Summary of AQMRAT findings for a Proposed RDF/SRF Production Facility at Nine Mile Point Industrial Estate

August 2016

Comments on Impacts at Adjacent Industrial Units

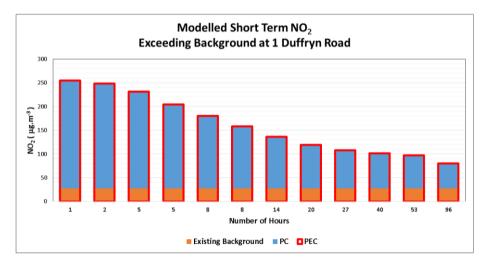
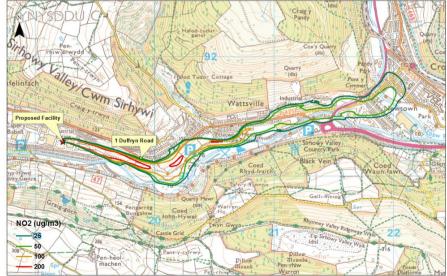
- Additional modelling was undertaken by AQMRAT using ADMS 5.1 and KLAM_21 to investigate the short term NO₂ impact at the adjacent industrial units. ADMS (with Calm module) was used to study the impact under stable conditions with low boundary height (i.e., due to temperature inversion). ADMS predicted ground level concentrations of NO₂ on the Nine Mile point industrial estate remained below the AQO.

- KLAM_21 modelling predicted very high hourly mean NO₂ concentrations at industrial units located immediately downstream (easterly direction) of the proposed SRF/RDF facility when the stack was within the cold air layer. However, KLAM_21 assumes that after the emission, the pollutant in the plume is uniformly distributed vertically throughout the cold air layer. In reality, the plume may not instantly be mixed vertically after release under stable conditions due to its momentum and buoyancy. A sensitivity analysis using ADMS under stable (Category G) meteorological conditions suggested that plume grounding at the adjacent industrial units was unlikely.
